# Response to Submissions Documentation

## Waterloo South

Stockland and Homes NSW

Revision B

Proposed CSSDA **RtS** LEP Amendments - Floor Space Ratio.

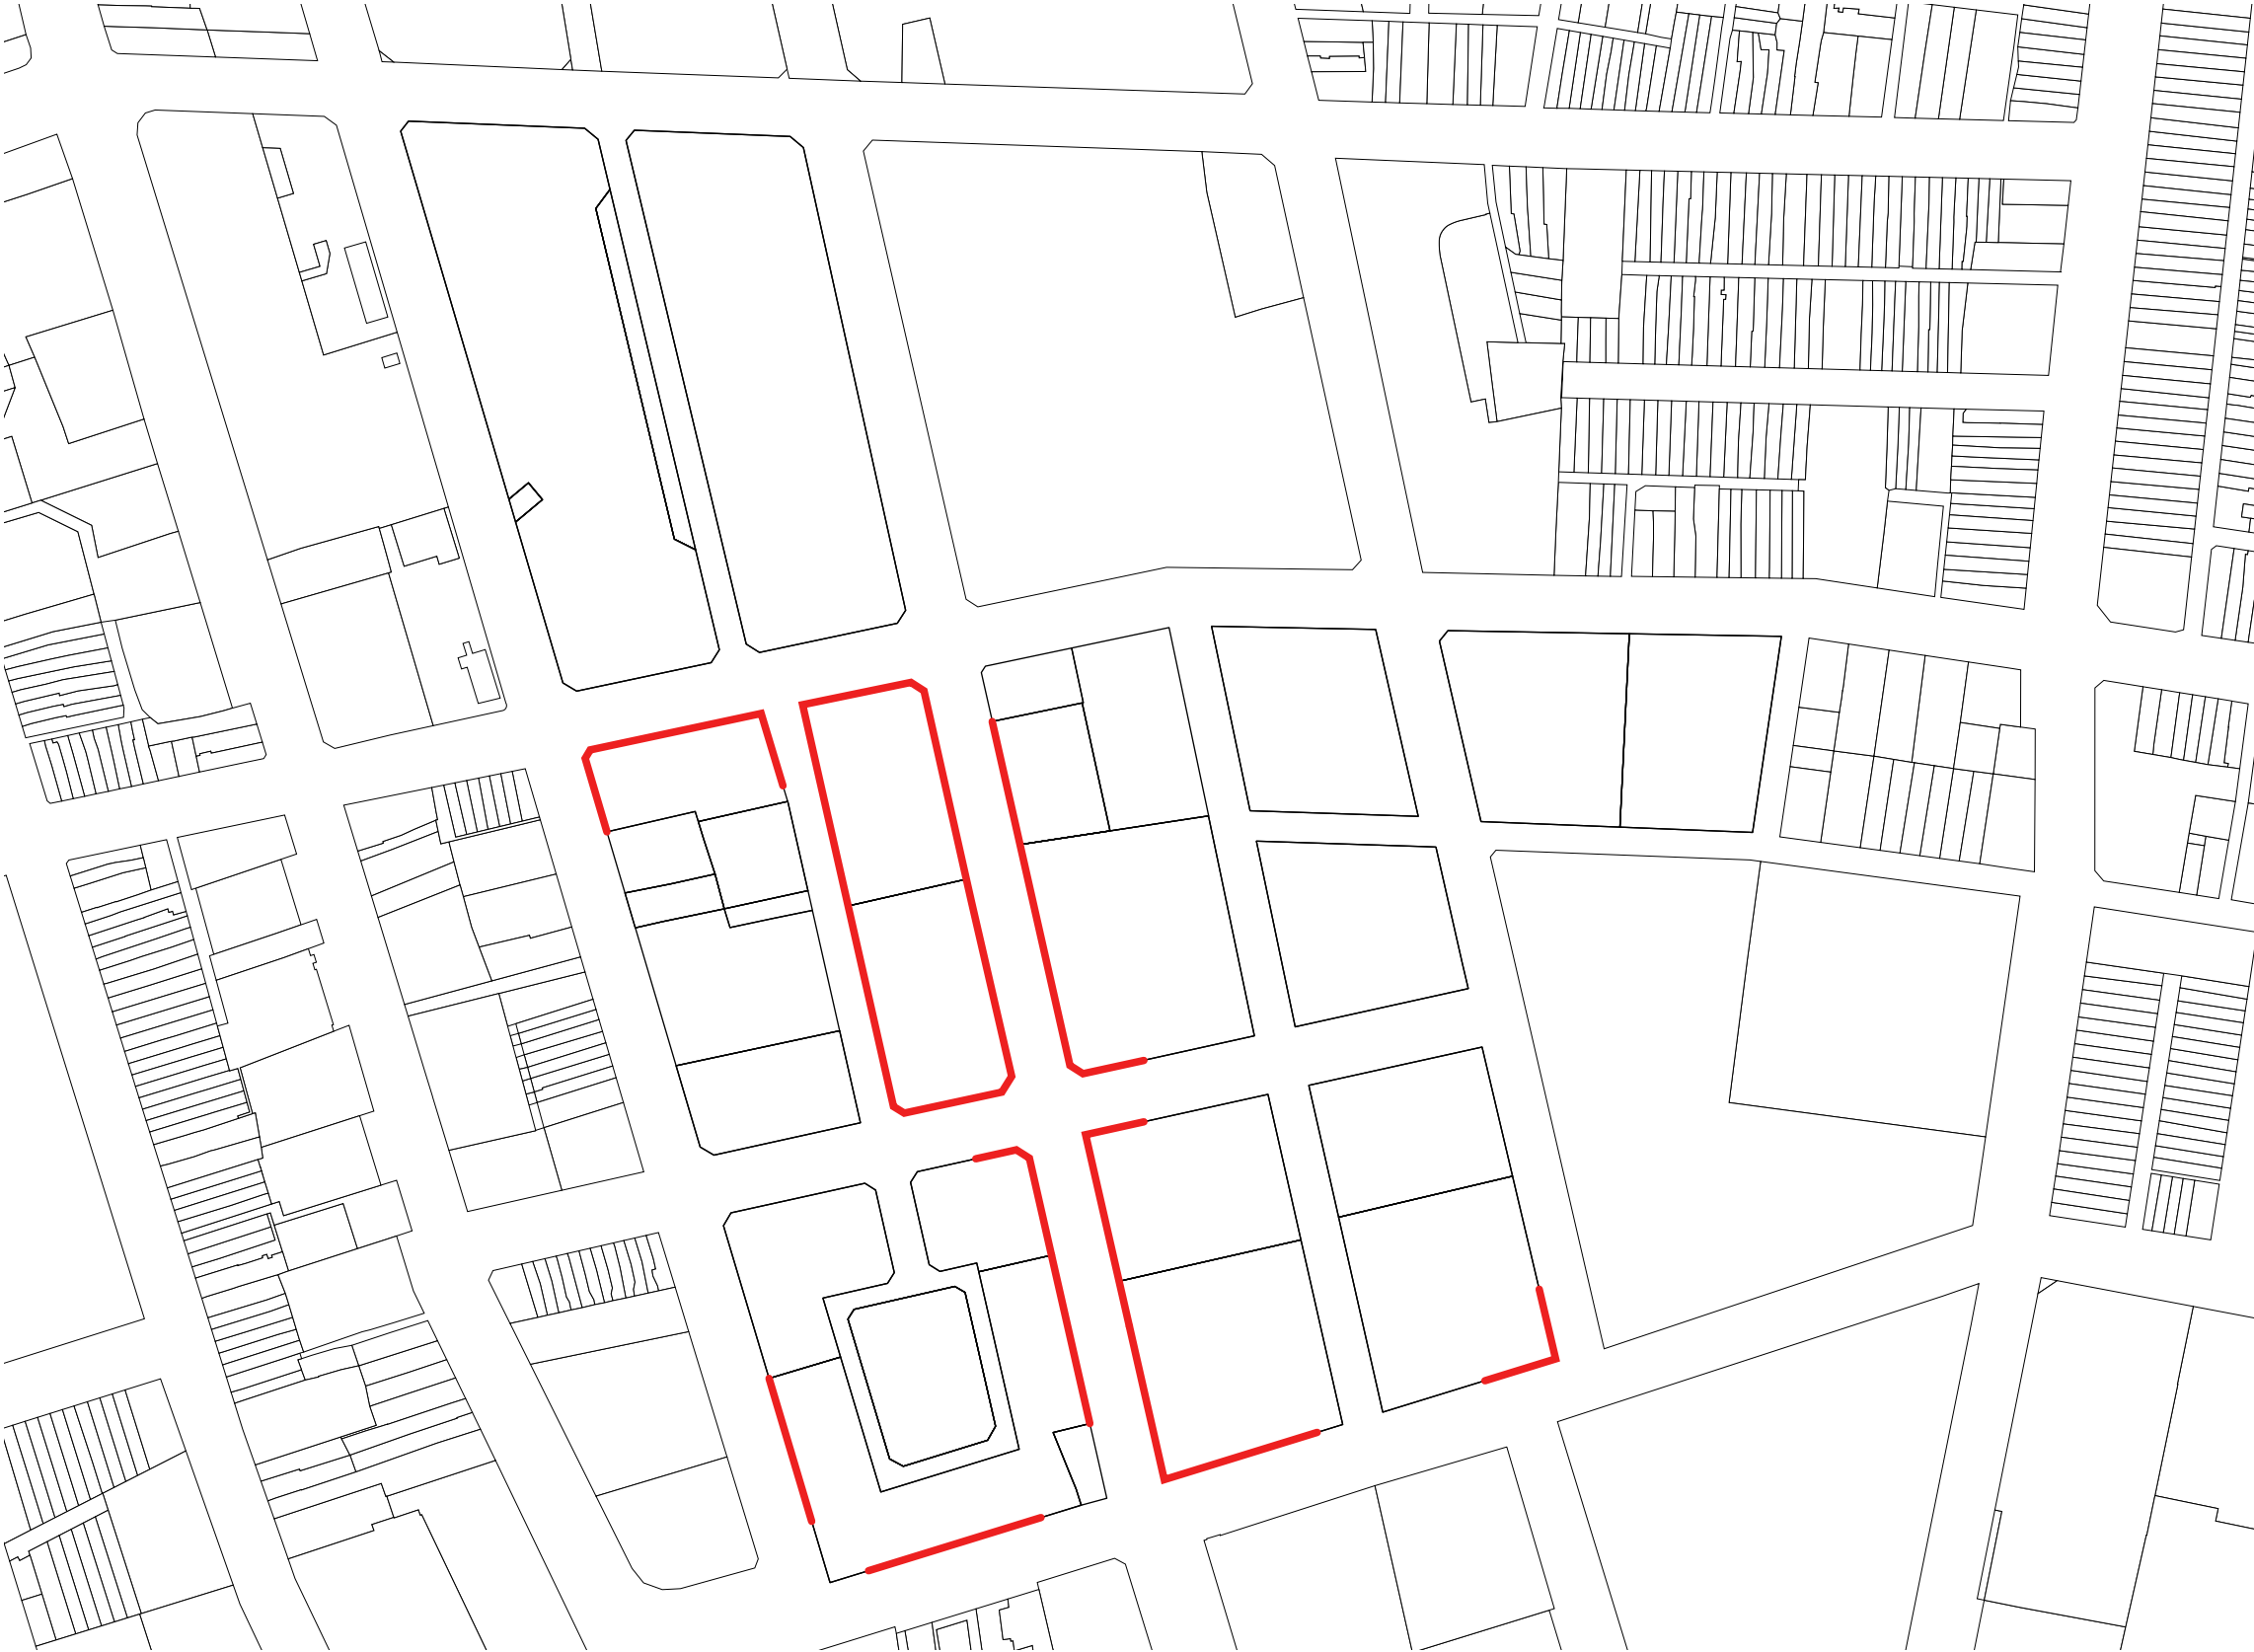
| Agency                                |  | Summary of Key Issues                                                                                                                                                                                                                                                                                                                                                                                                                                                                                                                                                                                                                                                                                                                                                                                                                                                                                                                                                                                                                                                                                                                                                                                                                                                                                                                                                                                              | Response                                                                                                                                                                                                                                                                                                                                                                                                                                                                                                                                                                                                                                           | Supporting RtS Documentation |
|---------------------------------------|--|--------------------------------------------------------------------------------------------------------------------------------------------------------------------------------------------------------------------------------------------------------------------------------------------------------------------------------------------------------------------------------------------------------------------------------------------------------------------------------------------------------------------------------------------------------------------------------------------------------------------------------------------------------------------------------------------------------------------------------------------------------------------------------------------------------------------------------------------------------------------------------------------------------------------------------------------------------------------------------------------------------------------------------------------------------------------------------------------------------------------------------------------------------------------------------------------------------------------------------------------------------------------------------------------------------------------------------------------------------------------------------------------------------------------|----------------------------------------------------------------------------------------------------------------------------------------------------------------------------------------------------------------------------------------------------------------------------------------------------------------------------------------------------------------------------------------------------------------------------------------------------------------------------------------------------------------------------------------------------------------------------------------------------------------------------------------------------|------------------------------|
| City of Sydney<br>Stockland           |  | <p><u>Floor Space Ratio</u></p> <p>There is insufficient information to confirm if the changes to the Floor Space Ratios on the maps are correct and are rationalised in the proposed envelopes and reference scheme. A comparative analysis will assist in confirming this.</p> <p>Further, as the lots have not yet been subdivided, the areas that will become parks it would be prudent to have FSRs of 0:1:1 on Block 1 and Block 8 parks and not be left unrestricted.</p> <p><u>Reallocation of Non-Resi use in Block 2C</u></p> <p>Minor adjustments to FSR based on reallocation.</p>                                                                                                                                                                                                                                                                                                                                                                                                                                                                                                                                                                                                                                                                                                                                                                                                                     | <ul style="list-style-type: none"><li>- Revised FSR based on 2C reallocation.</li><li>- FSR of 0.1:1 added to Block 1 &amp; Block 8 parks.</li><li>- Revised FSR based on updated Block 9A &amp; 10A areas to exclude the following TfNSW registered titles:<ul style="list-style-type: none"><li>— Lot 4 / DP252609</li><li>— Lot 5 / DP252609</li><li>— Lot 6 / DP 252609</li></ul></li></ul>                                                                                                                                                                                                                                                    |                              |

The revised FSR controls responds to the reallocation of social housing between Building 10A and Building 2C. This change retains the existing social housing provision within Building 2C, while transferring the originally proposed non-residential floor space from Building 2C to Block 10. An incremental increase of 0.01 FSR in Building 5A is also proposed to reconcile the overall GFA and FSR calculations to achieve closely to the GFA total of 282,485sqm. FSR of 0.1:1 has also been allocated to Block 1 and Block 8 parks.

The revision also responds to removal of TfNSW’s registered titles along McEvoy Street from the block areas.

Active Frontages (RtS)

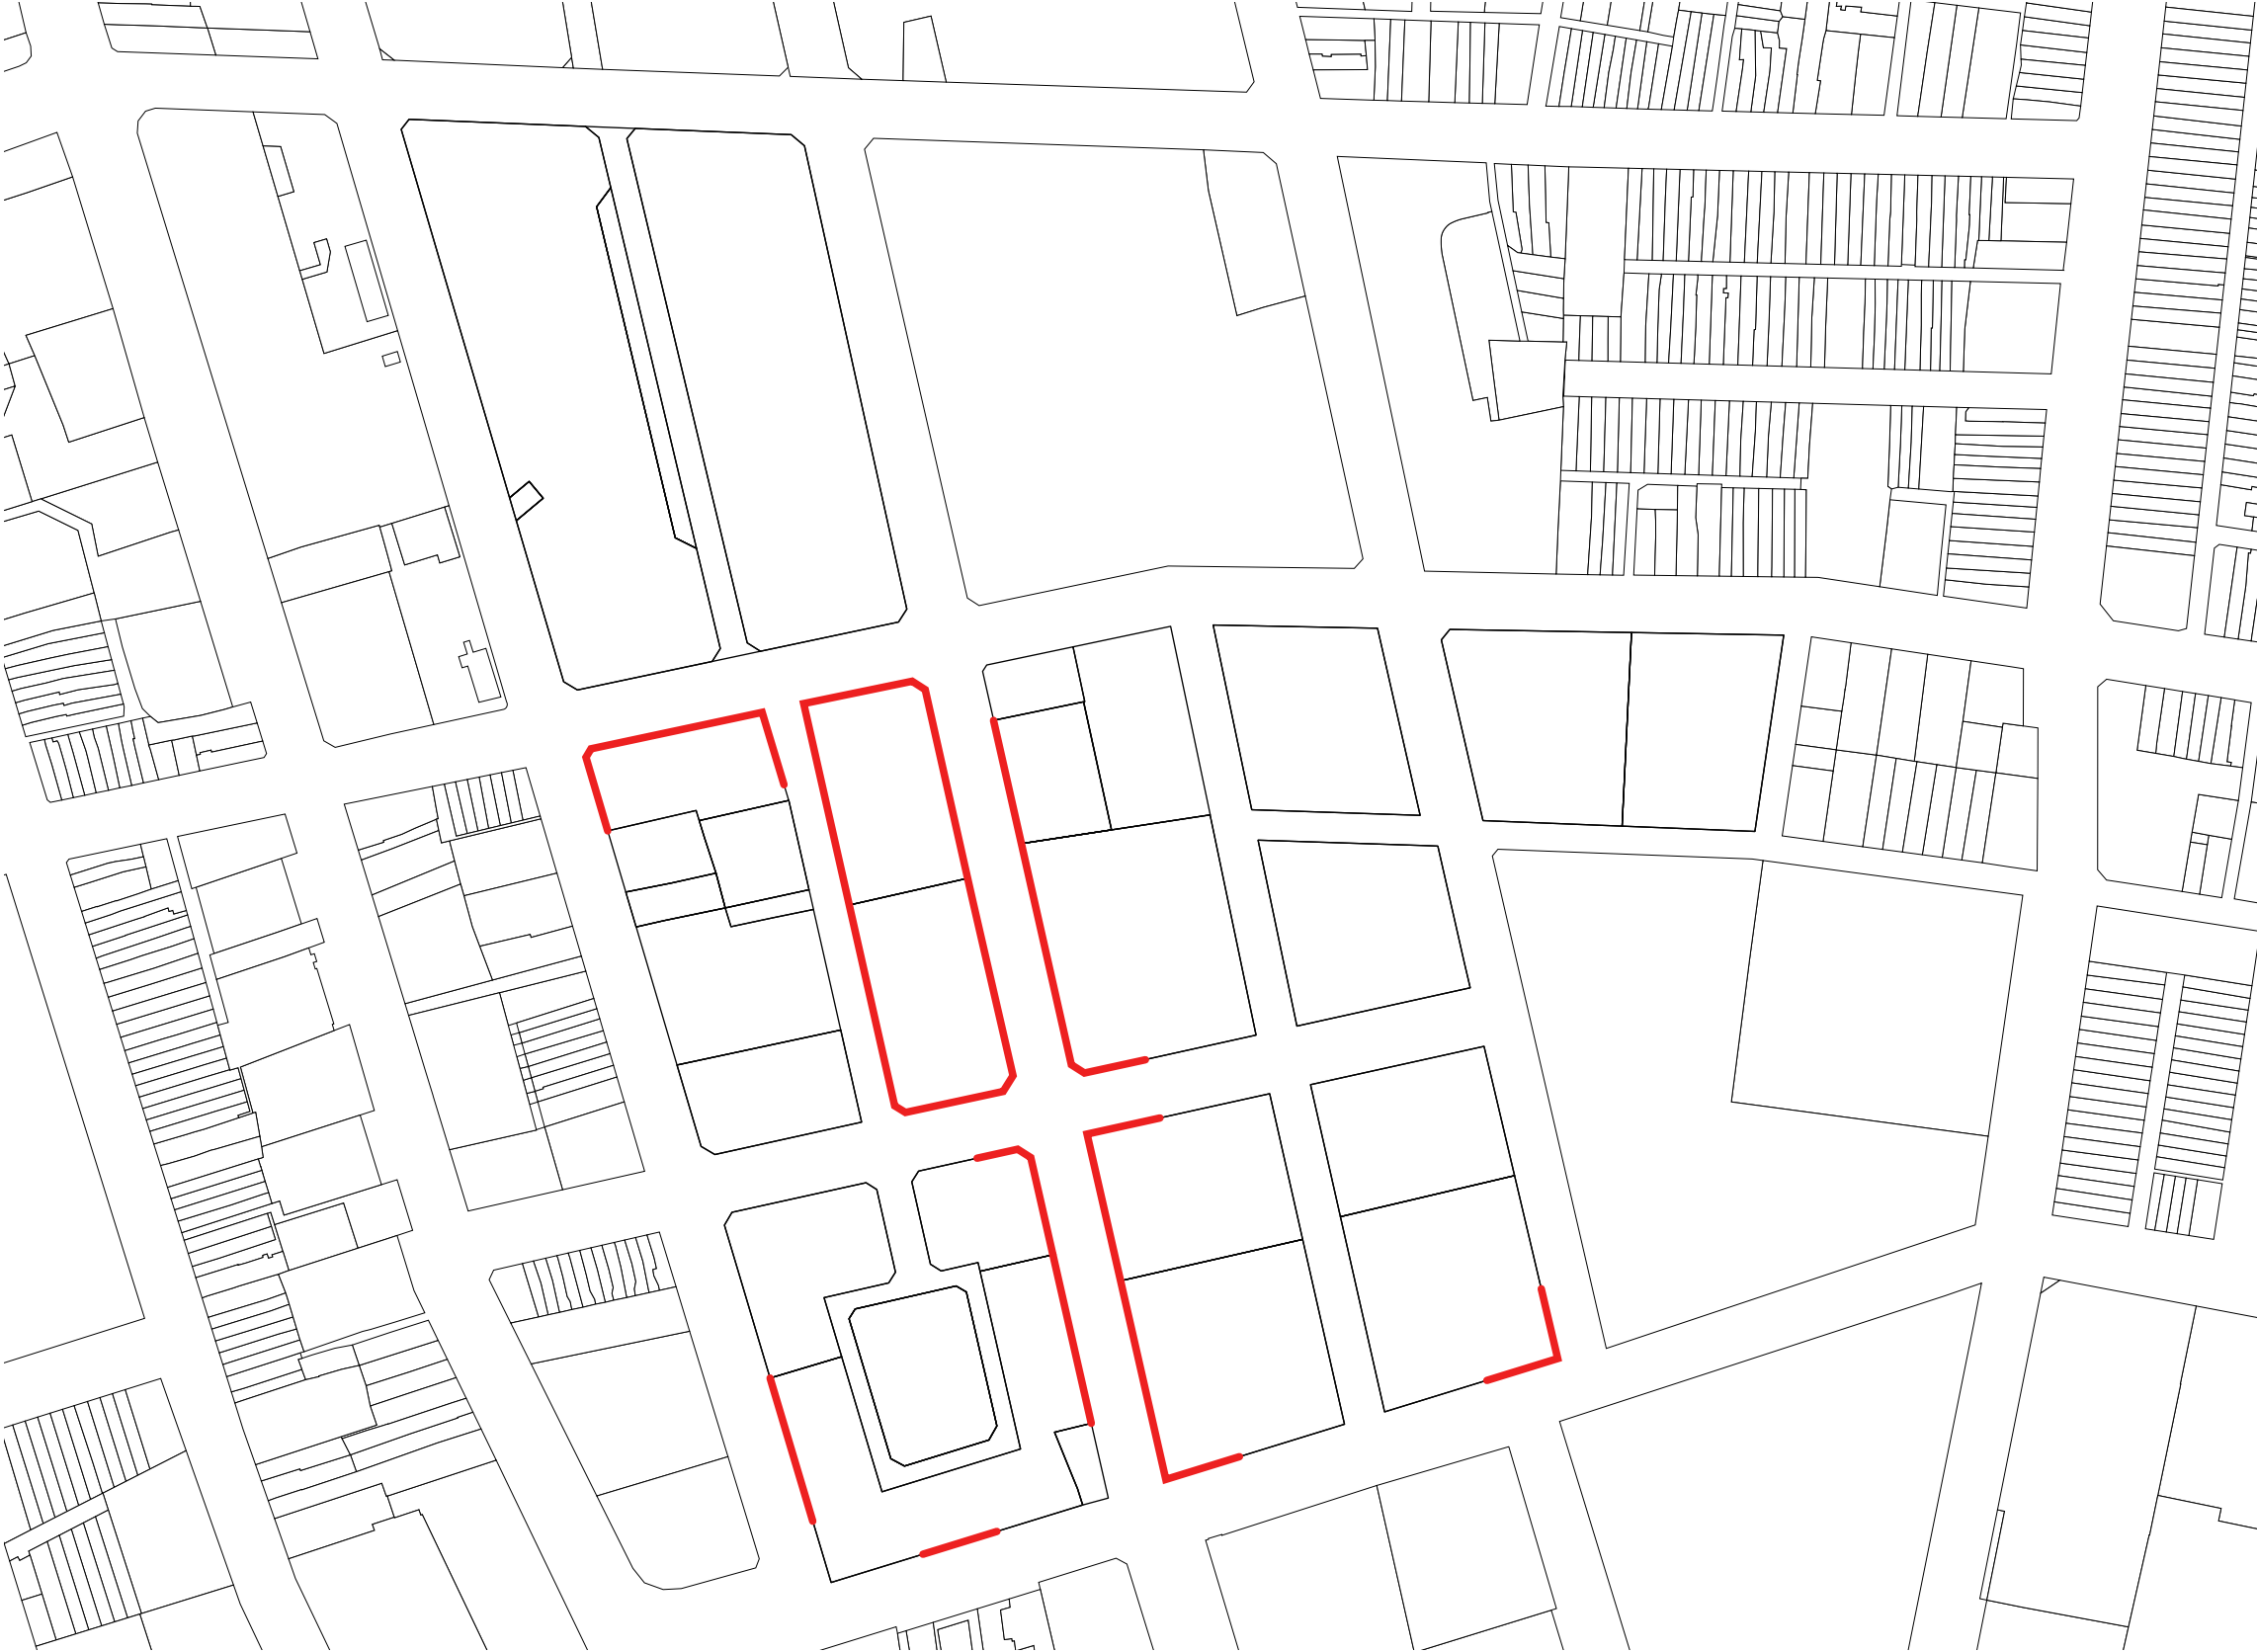
| Agency                                |  | Summary of Key Issues                                                                                                                                                                                                                                                                                                                                                                                                                                                                                                                                                                                                                                                                                                                                                                                                                                                                                                                                                                                                                                                                                                                                                                                                                                                                                                                                                                                              | Response                                                                                                                                                                                                                                                                                                                                                                                                                                                                                                                                                                                                                                           | Supporting RtS Documentation |
|---------------------------------------|--|--------------------------------------------------------------------------------------------------------------------------------------------------------------------------------------------------------------------------------------------------------------------------------------------------------------------------------------------------------------------------------------------------------------------------------------------------------------------------------------------------------------------------------------------------------------------------------------------------------------------------------------------------------------------------------------------------------------------------------------------------------------------------------------------------------------------------------------------------------------------------------------------------------------------------------------------------------------------------------------------------------------------------------------------------------------------------------------------------------------------------------------------------------------------------------------------------------------------------------------------------------------------------------------------------------------------------------------------------------------------------------------------------------------------|----------------------------------------------------------------------------------------------------------------------------------------------------------------------------------------------------------------------------------------------------------------------------------------------------------------------------------------------------------------------------------------------------------------------------------------------------------------------------------------------------------------------------------------------------------------------------------------------------------------------------------------------------|------------------------------|
| Stockland                             |  | <p><u>Active Frontages</u></p> <p>Amend to align with Stage One design.</p>                                                                                                                                                                                                                                                                                                                                                                                                                                                                                                                                                                                                                                                                                                                                                                                                                                                                                                                                                                                                                                                                                                                                                                                                                                                                                                                                        | <p>Active frontages along McEvoy Street on Blocks 8 &amp; 9 amended to reflect Stage One treatment as confirmed by Stockland,</p>                                                                                                                                                                                                                                                                                                                                                                                                                                                                                                                  |                              |

Active frontages along McEvoy Street on Blocks 8 & 9 amended to reflect Stage One design which is being designed concurrently.
